Design Review Board Agenda

15728 Main Street, Mill Creek, Washington 98012

March 16, 2017

| A. Arena Sports – Building Elevations, Materials & Colors, Landscaping, and Signage ⁽²⁾ | |

SHEET NUMBER
L-2

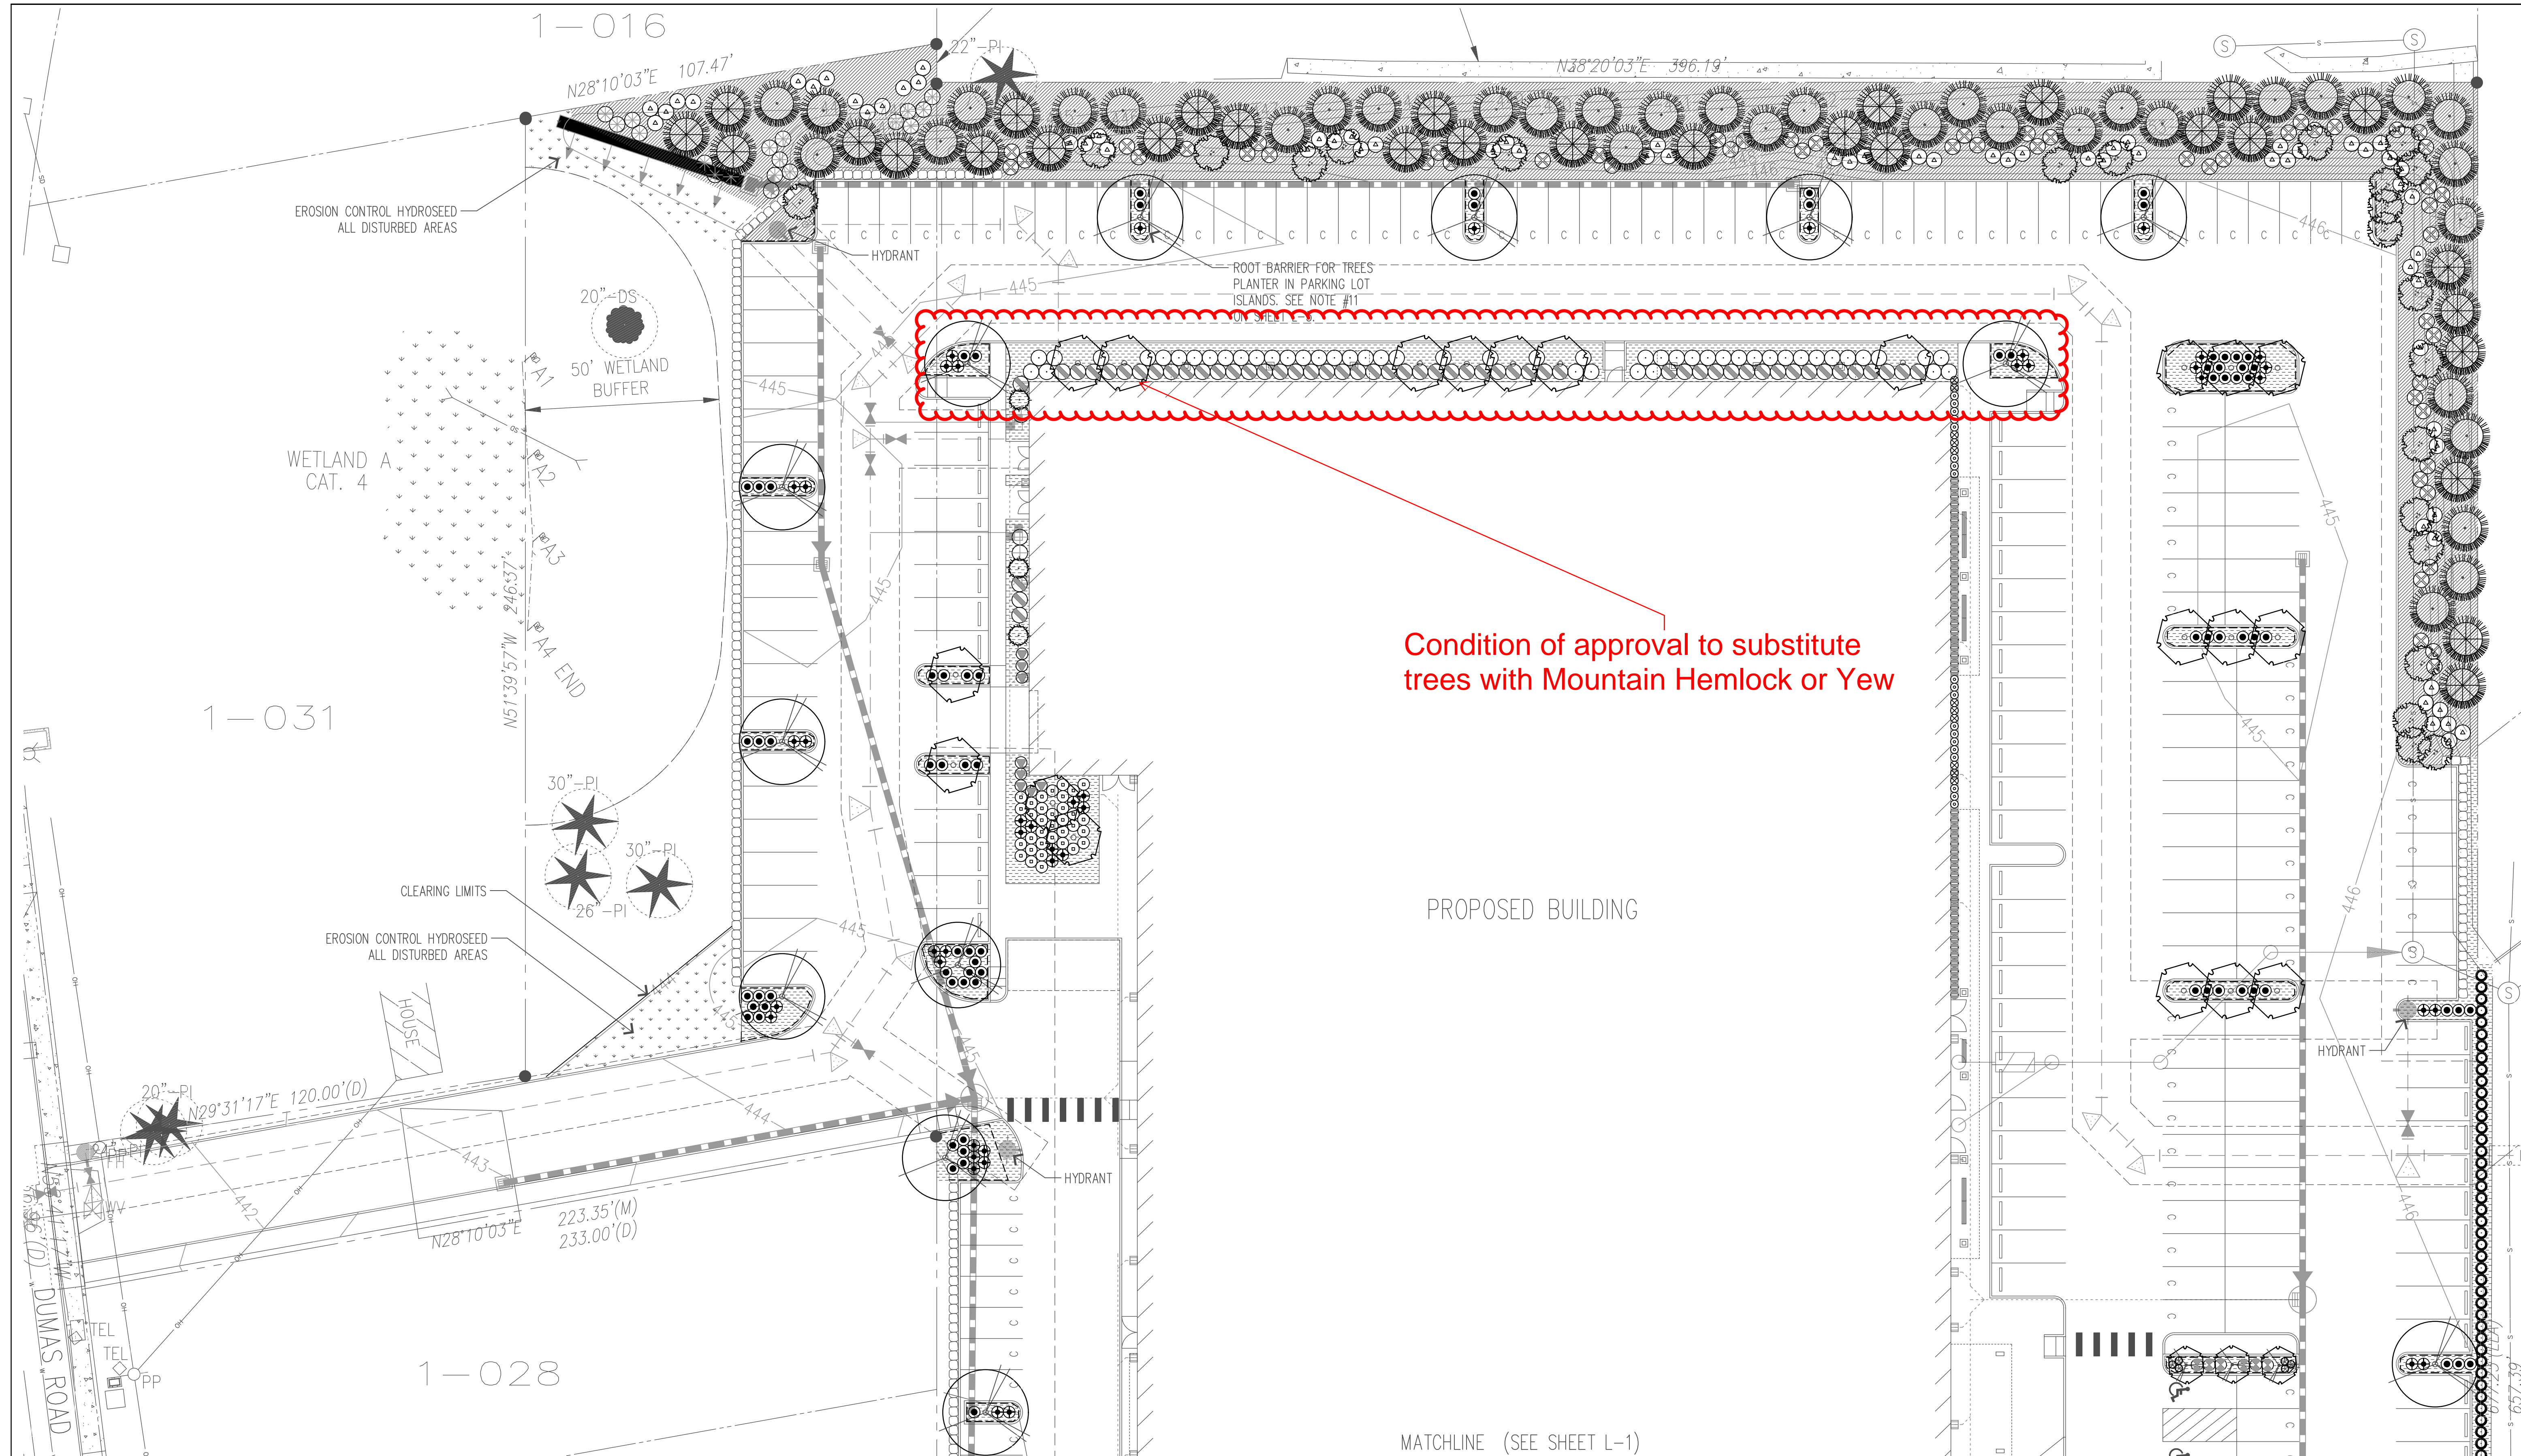
To address the concerns of the potential impacts of light, noise and screening of the proposed project on the residents to the west, the applicant is proposing to retain the existing 6 foot cedar fence located on the Rivenhdale HOA property (see **Attachment 5 – Landscape Plan Sheet L-5**) and provide a 25 foot wide landscape buffer on the western property boundary. The buffer includes a berm which is to be a maximum height of 8 feet on the north and 2 feet on the south. The applicant has minimized grading to retain the large fir on the south end of the berm. To provide a dense screen between the proposed facility and residential uses (both approximately 35 tall) a mix of evergreen trees (Western Red Cedars and Douglas Firs), shrubs (compact Oregon Grape, Redtwig Dogwood, and Snowberry) and groundcover (Salal) are proposed.

Consistent with the DRB comments on the informal review, staff is recommending that trees within the 25 foot wide landscape buffer range between six to ten feet in height at the time of planting.

In addition, at the informal DRB meeting the DRB suggested the applicant remove the sidewalk along the western side of the building and install a landscape bed to help better screen the building from the view of the residential homes. In response, the applicant is proposing a 10 foot wide landscape bed along this side of the building. The applicant is proposing to install deciduous trees (Pacific Sunset Maples, Frans Fontaine Hornbeam), shrubs (Otto Luken Laurel and Spring Bouquet Viburnum) and groundcover (Kinnickinnick).

Consistent with the DRB Informal Review comments, staff is recommending as a condition of approval that the applicant replace the Pacific Sunset Maples and Frans Fontaine Hornbeam with a columnar evergreen tree variety such as a Mountain Hemlock and/or Yew to be clustered and/or spaced along the western side of the building to provide maximum year around screening of the structure.

6. The Pacific Sunset Maple and Frans Fontaine Hornbeam proposed in the 10-foot landscape bend adjacent to the western elevation of the building and in the landscape island on the north and south ends, shall be replaced with a columnar evergreen tree variety such as a Mountain Hemlock and/or Yew to provide year around screening of the structure.

SHEET CONTENTS
TREE SCHEDULE

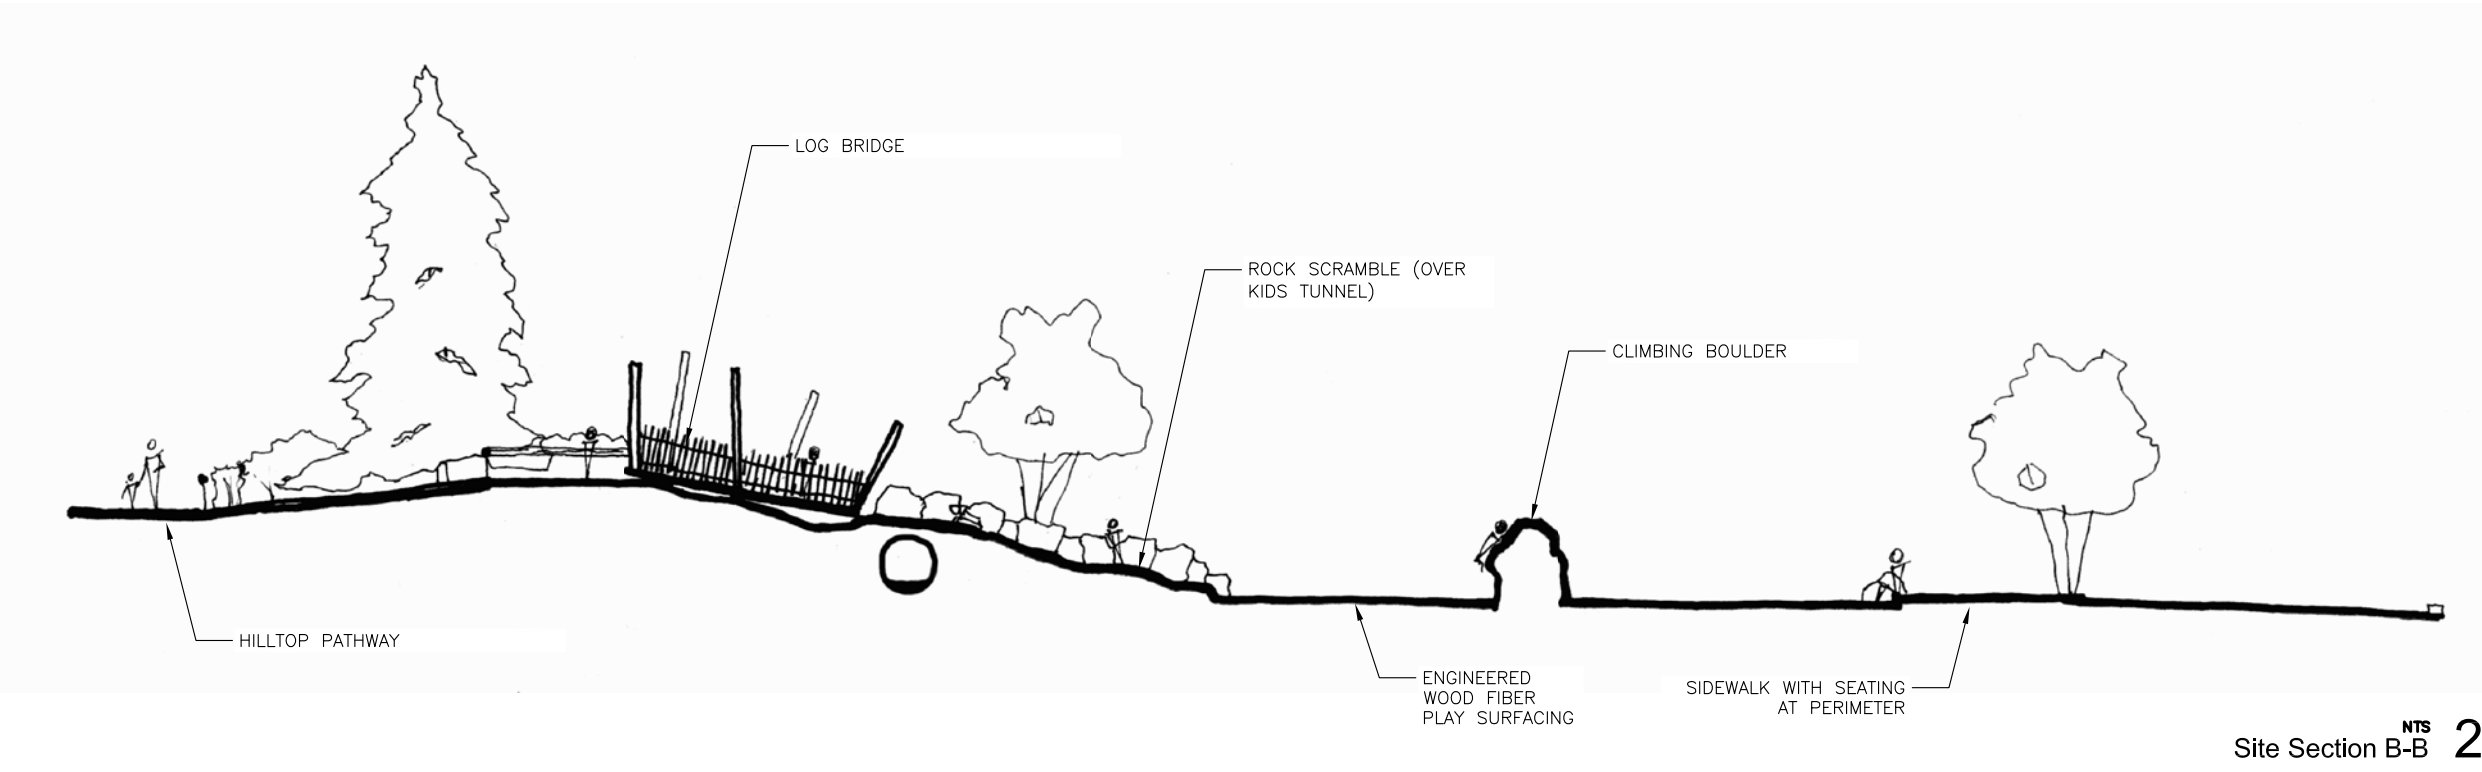
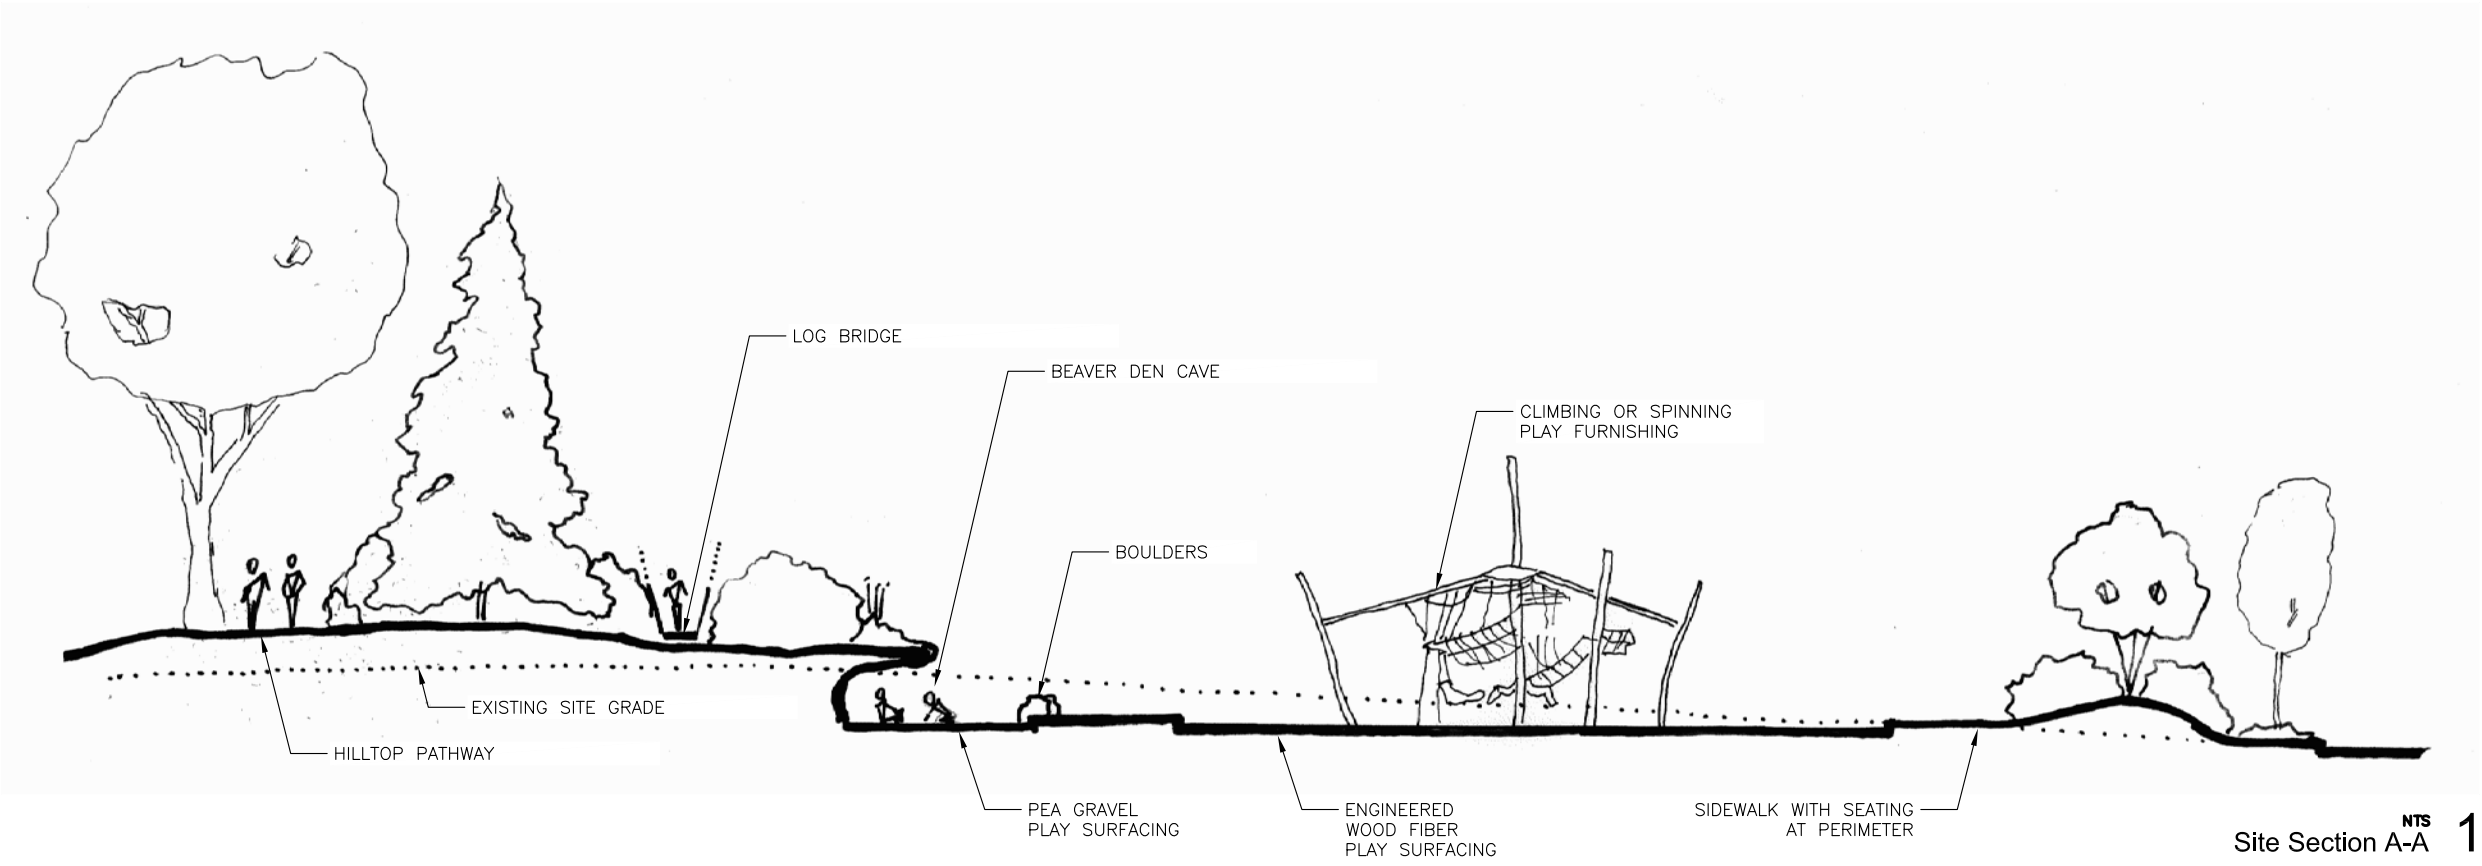
Another area where the Board’s guidance is being sought is the proposed tree selection. There are five categories of trees proposed (Sheet L1.1): *accent trees* to be used at the entry and in the Lowland Meadow landscape bed on the southern boundary between the sidewalk and the street, *conifer trees*

proposed on the berm, *shade trees* primarily to be used around the perimeter of the park, *small trees* used in the Woodland Meadow landscape bed on the western boundary and on the berm, *wet tolerant trees* to be used in the dry creek bed and on the edge of the rain garden. Where symbols are associated with multiple trees, the intent is to select, with the DRB’s input, one of the trees for the final plan. Staff has two suggestions with regard to the trees: remove the London Plane because of maintenance concerns, and remove the Dove Tree because it needs afternoon shade and the western location will have full afternoon sun. The existing street trees surrounding the park, which are a Green Ash, will be retained.

SHEET CONTENTS
 PLANT SCHEDULE

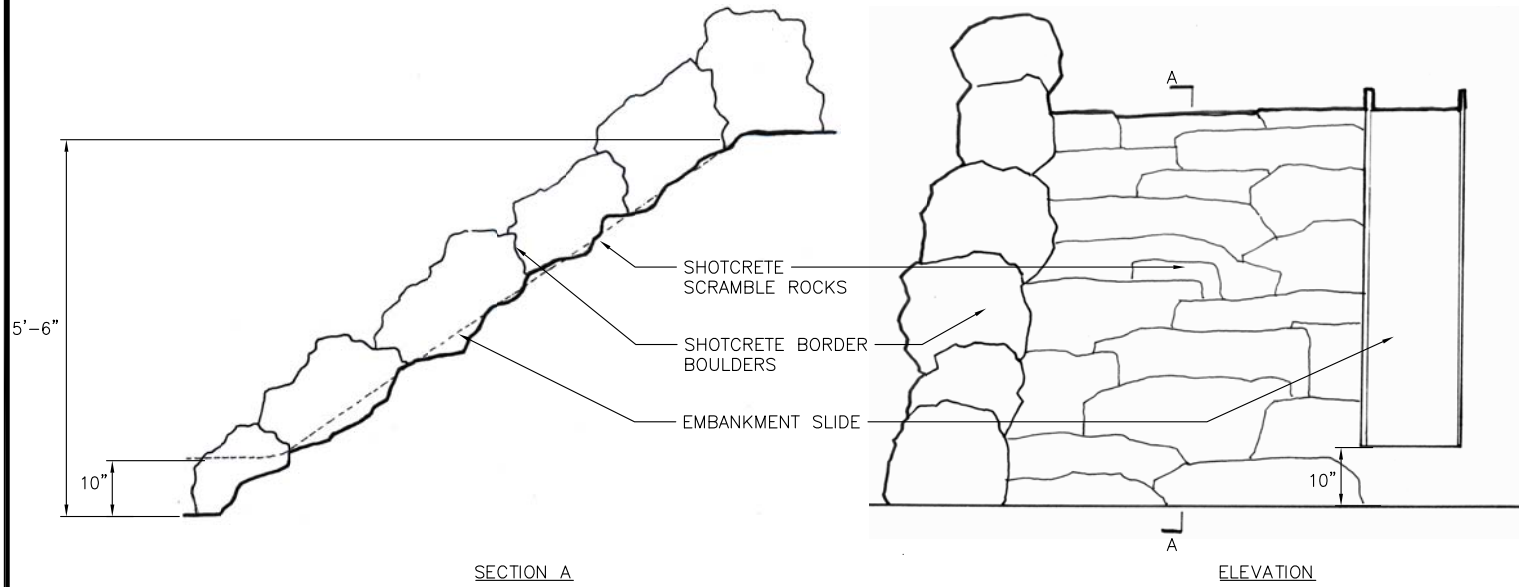
The landscape plan is divided into individual areas, with a plant palette proposed for each area (Sheet L2.1). The areas are: Lowland Meadow, Marsh/Creek (for the rain garden), Woodland Forest, and lawn, which are listed on Sheet L1.2.

- The *Lowland Meadow* areas are around the perimeter of the rain garden and along the southern property boundary between the sidewalk and the street. The Lowland Meadow plant palette consists of mostly drought tolerant plants, with a mix of evergreen and perennials.
Staff Recommendation: Remove Tufted Hair Grass because of disease and insect susceptibility and Western Sword Fern because it does not do well in a sunny location.

- The *Marsh / Creek* area is on the northwest boundary at the base of the dry creek bed. The plant palette proposes mostly native plants with a mix of evergreen and deciduous plants.
Staff Recommendation: Remove Iris Tenax because it will not tolerate wet feet, and Skunk Cabbage and Goat’s Beard because they require shade. Typically a rain garden has three zones, which each require a different type of plant. The current palette consists mostly of Zone 1 plants. There are several plants proposed in both the Lowland Meadow and Woodland Forest that could fill the function of Zone 2 and Zone 3, such as: add Oregon Grape, Pacific Nine Bark and Snowberry for Zone 2 and Lavender, Maiden Grass, and Red Currant for Zone 3 plants.

- The *Woodland Forest* is proposed for the top of the berm on either side of the foot bridges, in the dry creek bed, and along the western boundary of the property between the sidewalk and the street, as well as at the eastern entrance by the park sign. The plants are natives and are primarily drought tolerant with about half being evergreen. These plants are intended to form a denser thicket and many have thorns, which will deter intrusion into these areas. The area at the top of the berm is steeper and would not be safe for play.
Staff Recommendation: Remove Lady Fern because it needs shade, and replace the Bald-Hip Rose with another a rose cultivar more suited to the sunny location such as Rosa ‘Marchesa Boccella’ or Rosa ‘De Rescht.’
